## 3 Proposed design changes

### 3.1 Amendments to motorway-to-motorway interchange at the M7 Motorway

**Figure 3-1** M12 Motorway to M7 Motorway Interchange

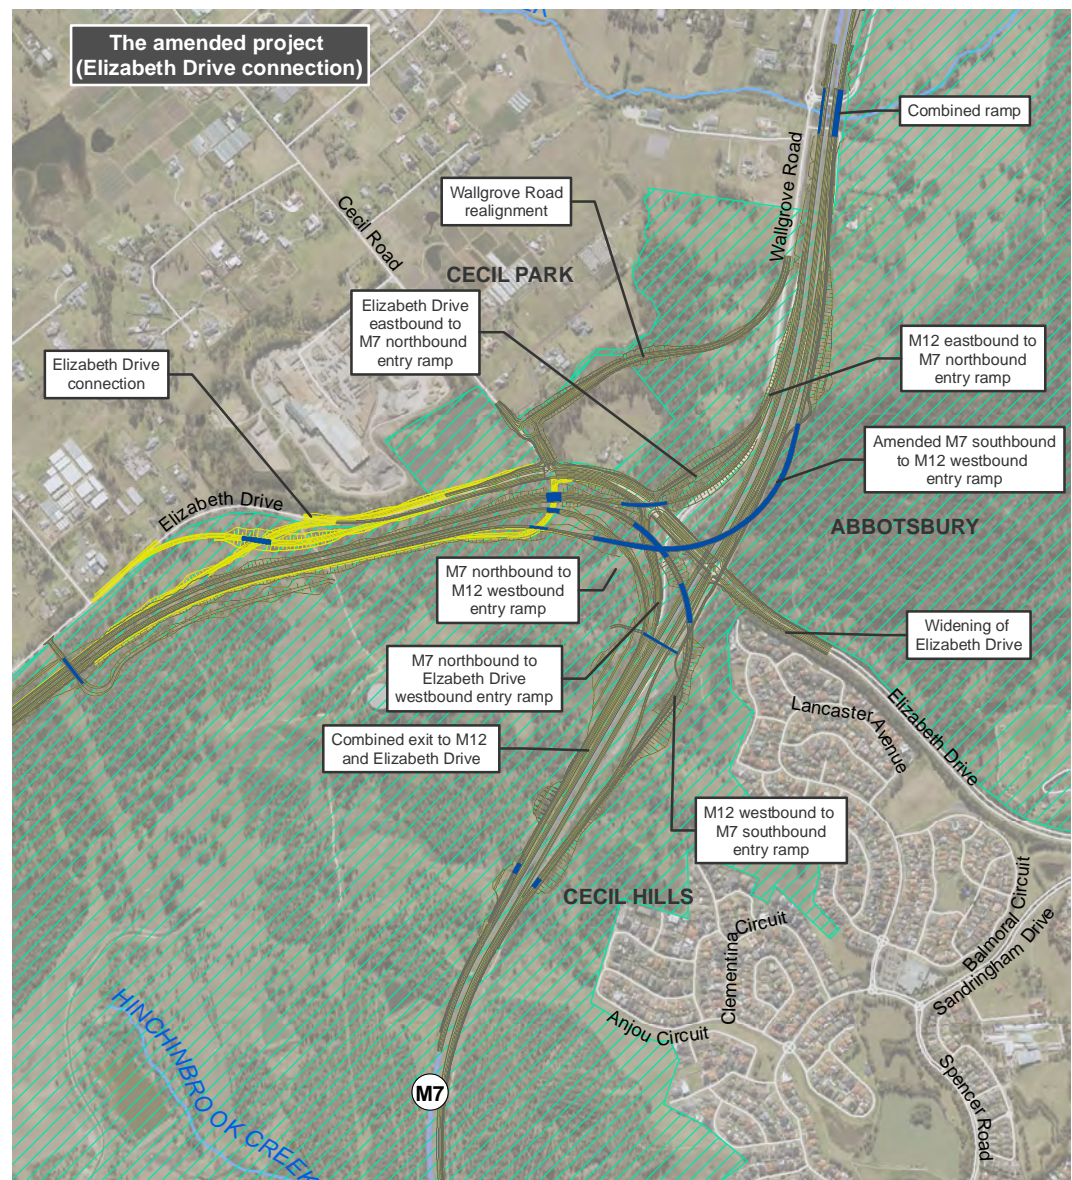
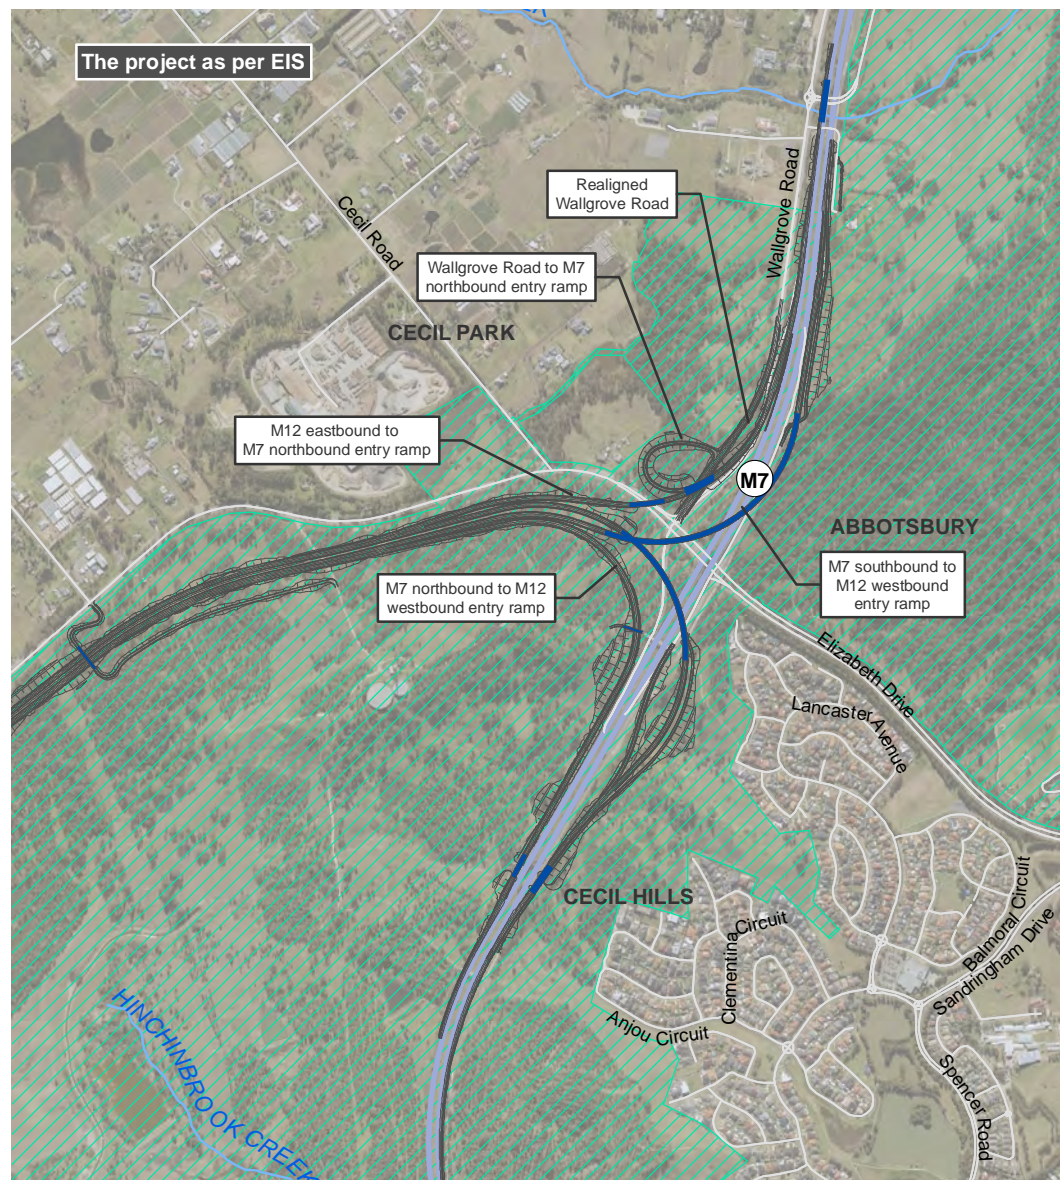
The proposed design change for option 1 of the motorway-to-motorway interchange at the M7 Motorway consists of the following and is shown in **Figure 3-1**:

- Two amended intersections of Elizabeth Drive to the M7 Motorway, including changes to the lane configuration of the existing M7 Motorway connection to Elizabeth Drive as follows:

- Updated lane configuration of the existing intersection of the M7 Motorway southbound and Elizabeth Drive
  - Changes to the existing intersection of the M7 Motorway and Wallgrove Road with Elizabeth Drive, including:

- Changes to lane configuration
    - Removal of the loop ramp
    - Realignment of Wallgrove Road to connect to Cecil Road, including a connection between Elizabeth Drive and Wallgrove Road via Cecil Road with a signalised intersection with Elizabeth Drive

- Direct connection from Elizabeth Drive to the M7 Motorway northbound
- Widening of Elizabeth Drive under the M7 Motorway and approaches
- Amended exit ramps from the M7 Motorway to the M12 Motorway and Elizabeth Drive

- The exit ramps would provide a combined exit to both the M12 Motorway and Elizabeth Drive, and would then diverge to provide separated entry to the M12 Motorway and Elizabeth Drive

- Realignment of the existing M7 Motorway shared user path from the alignment proposed in the EIS
- Changes to the proposed M12 Motorway road alignment at the lead up to the interchange including modifications to bridges, culverts and other structures

- Changes to some of the existing and proposed water quality treatments.

Combining two M7 Motorway off-ramps into a single exit point from the motorway before diverging for access to M12 Motorway or Elizabeth Drive would improve operational performance and driver safety. This is due to the reduction in locations where vehicles would be merging left and decelerating to exit the motorway. A single exit point would also reduce driver confusion. Similarly for the ramps exiting the M12 Motorway, the combination into a single exit point from the motorway before diverging would improve safety and performance.

The high point of the amended interchange ramps (see **Figure 3-1**) would be lower than the high point of the interchange ramps as described in the EIS. The high point of the amended M7 Motorway southbound to M12 Motorway westbound ramp would be lowered by about five metres when compared to the project as described in the EIS, and the high point of the amended M12 Motorway Eastbound to M7 Motorway southbound ramp would be lowered by about four metres when compared to the project as described in the EIS. It is noted this may be further amended in detailed design.

**Figure 3-2** Proposed amended project bridges

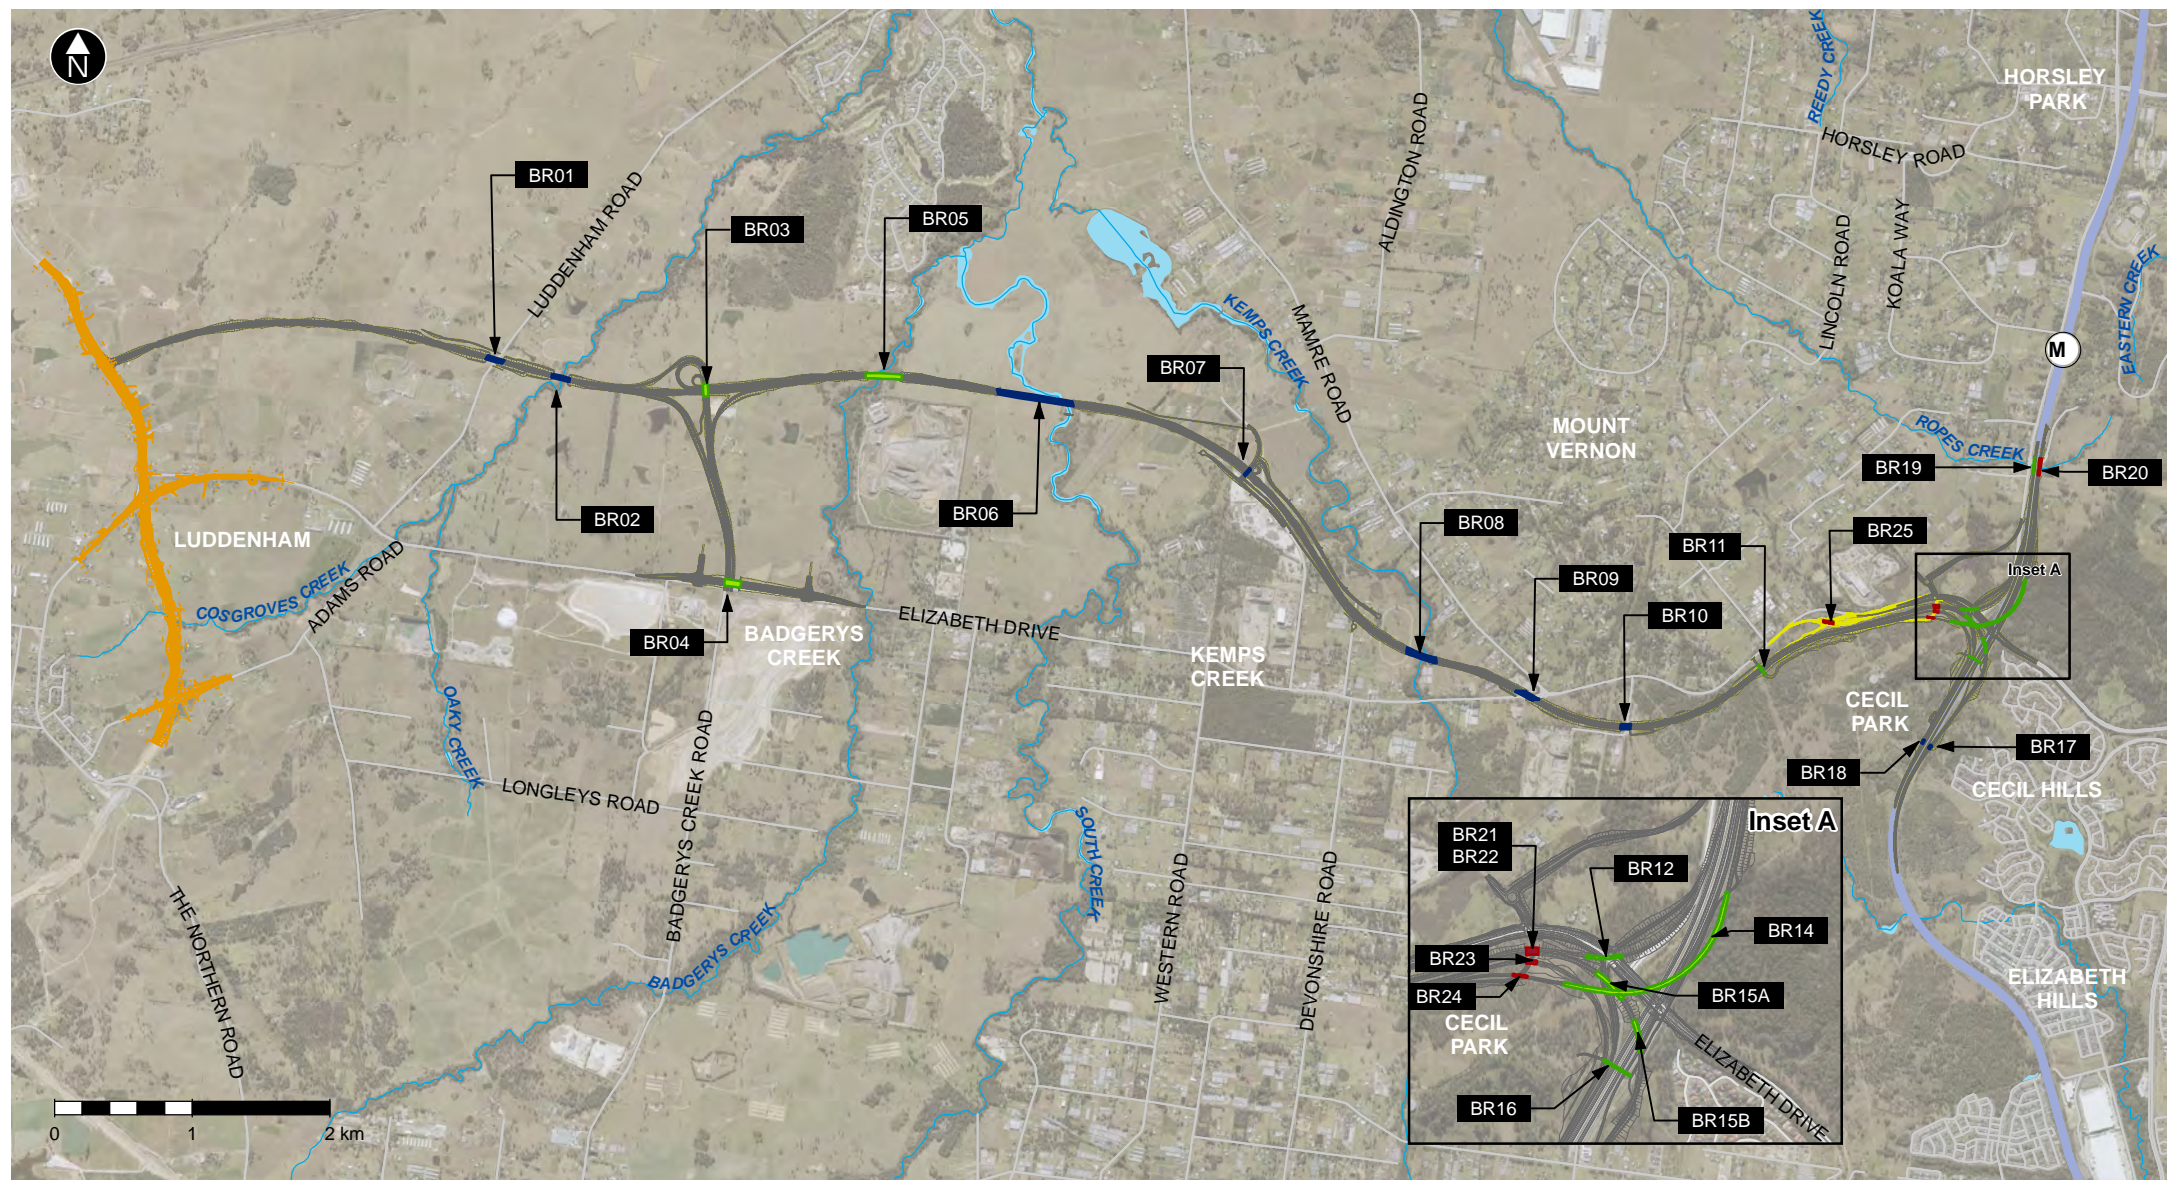
The described amendments to the motorway-to-motorway interchange at the M7 Motorway would result in changes to bridges as they were described in Section 5.12 of the EIS. Bridge 13 would no longer be required, and five additional bridges are proposed, primarily to facilitate a connection between the M12 Motorway and Elizabeth Drive, bringing the total number of bridges constructed to 23. The additional bridges would be constructed in the form of a multi-span precast concrete super-T girder, an example of which is shown in Figure 5-10 of the EIS. Details of the new bridges are listed in **Table 3-1** and shown in **Figure 3-2**.

Bridge reference and description	Indicative structure type	Indicative length (L) and width (W) in metres (m)
<b>Bridge 20</b> Widening of the existing the Villiers Road bridge (Bridge 19) at the M7 Motorway southbound Configuration would be one additional traffic lane and shared user path	Multi-span precast concrete super- T girder	L = about 120 m W = about 8 m
<b>Bridge 21</b> M7 Motorway northbound entry ramp from M12 Motorway eastbound Bridge over M12 Motorway westbound entry ramp from Elizabeth Drive Configuration would be one lane and shoulder	Multi-span precast concrete super- T girder	L = about 36 m W = about 6 m
<b>Bridge 22</b> M7 Motorway southbound entry ramp from M12 Motorway eastbound bridge over M12 Motorway westbound entry ramp from Elizabeth Drive Configuration would be two lanes and shoulder	Multi-span precast concrete super- T girder	L = about 36 m W = about 10 m
<b>Bridge 23</b> M7 Motorway northbound exit ramp to M12 Motorway westbound bridge over M12 Motorway westbound entry ramp from Elizabeth Drive Configuration would be two lanes and shoulder	Multi-span precast concrete super- T girder	L = about 36 m W = about 10 m

<b>Bridge 24</b> M7 Motorway southbound exit ramp to M12 Motorway westbound bridge over M12 Motorway westbound entry ramp from Elizabeth Drive Configuration would be two lanes and shoulder	Multi-span precast concrete super- T girder	L = about 36 m W = about 10 m

**Figure 3-3** Key differences between option 1 and option 2 of the amended project

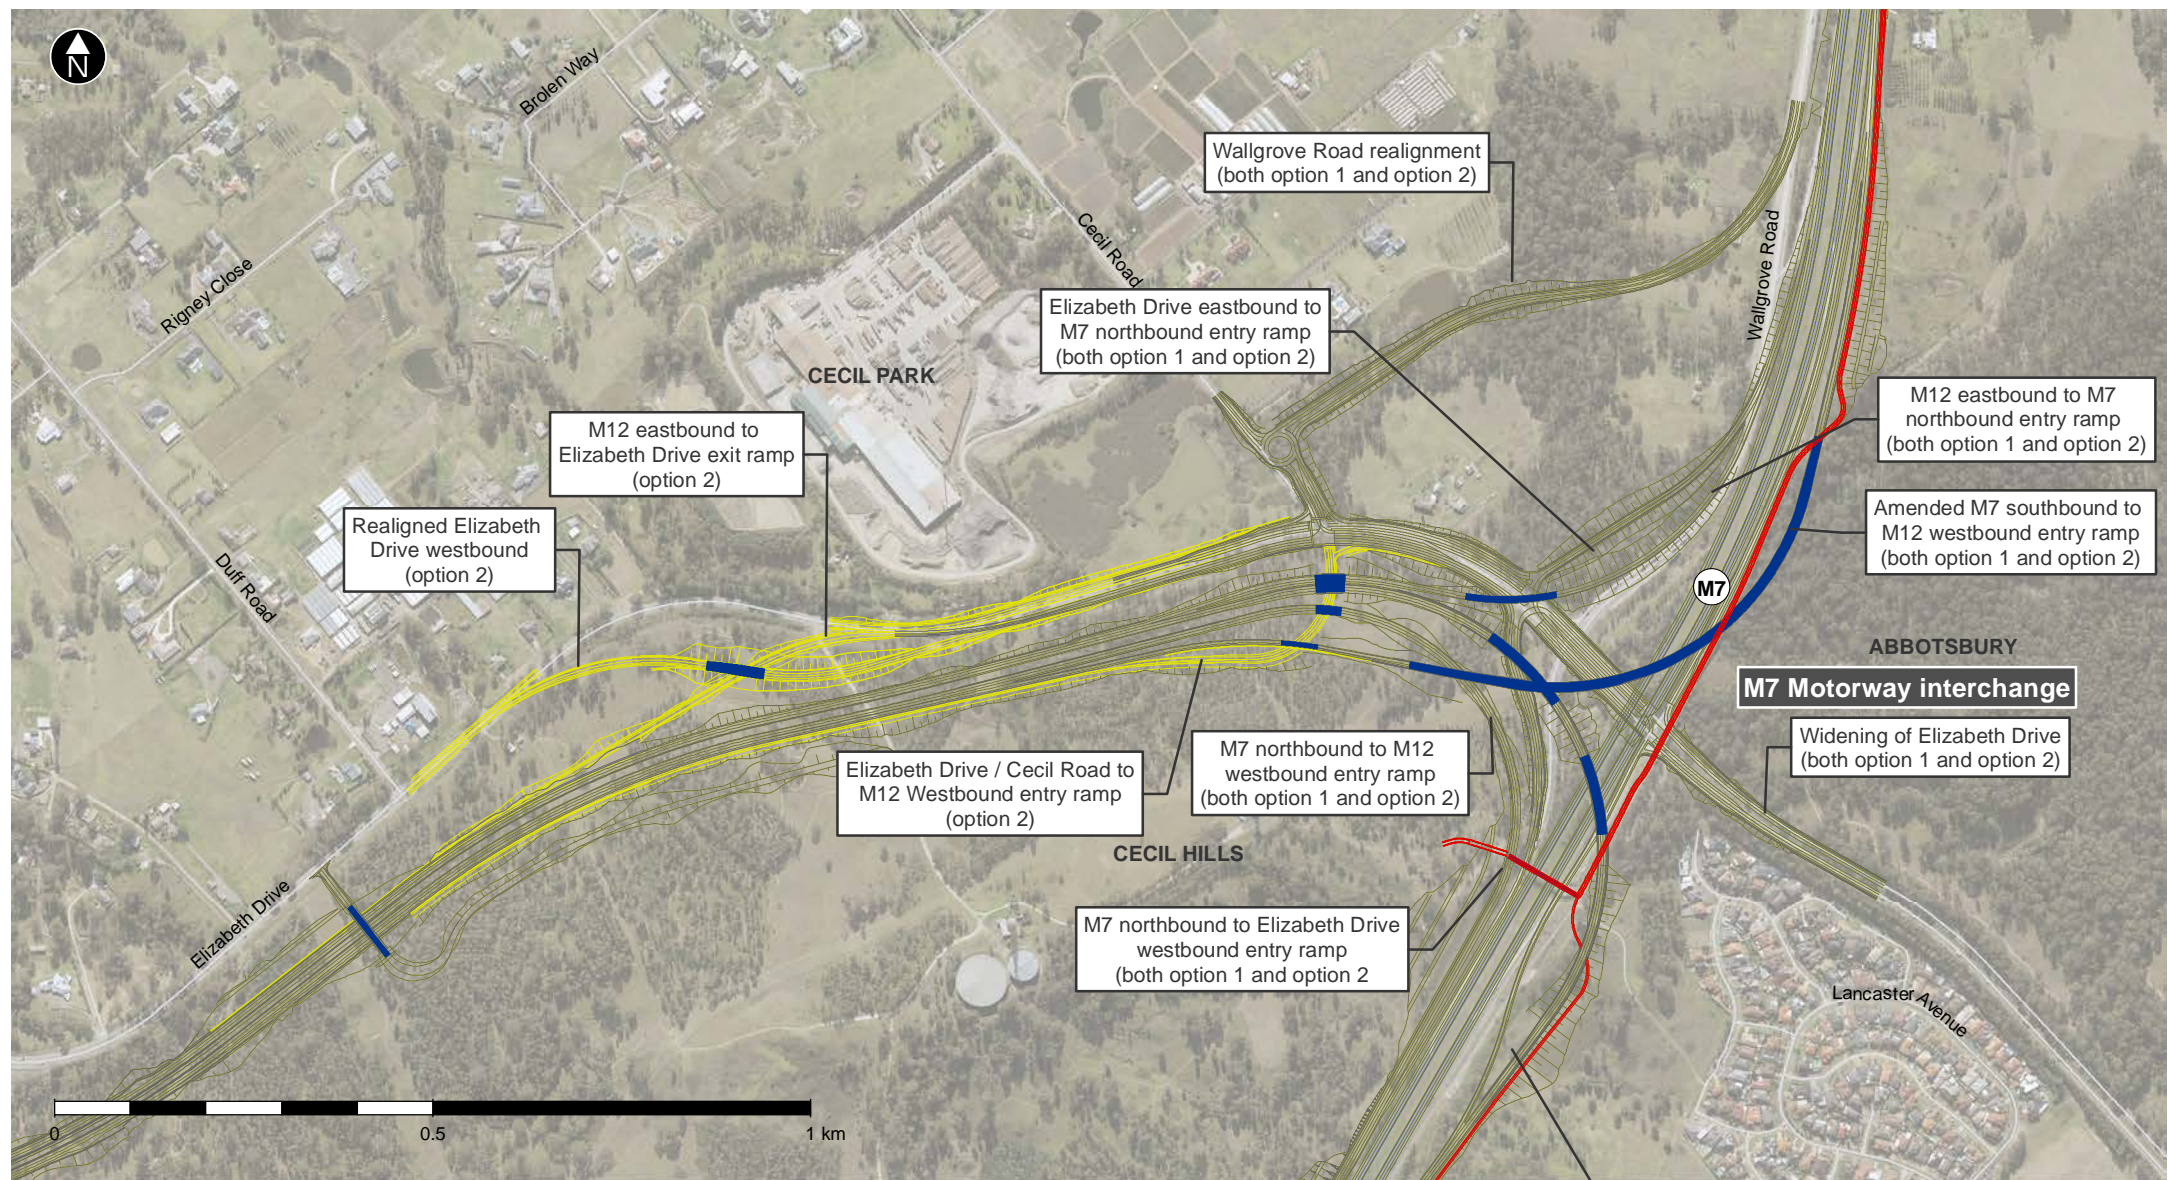
The proposed changes to the design of option 2, when compared to option 1, are shown in **Figure 3-3**. The amended project to the west of Duff Road would be consistent between option 1 and option 2.

Option 2 (with Elizabeth Drive connections) would result in an additional bridge, Bridge 25, bringing the total number of bridges constructed to 24. The additional bridge would be constructed in the form of a multi-span precast concrete super-T girder, an example of which is shown in Figure 5-10 of the EIS. Details of the new bridge are listed in **Table 3-2** and shown in **Figure 3-2**.

Bridge reference and description	Indicative structure type	Indicative length (L) and width (W)
<b>Bridge 25</b> Elizabeth Drive westbound Bridge over M12 Motorway eastbound exit ramp to Elizabeth Drive Configuration would be two lanes and shoulder.	Multi-span precast concrete super-T girder	L = about 36 metres W = about 10 metres
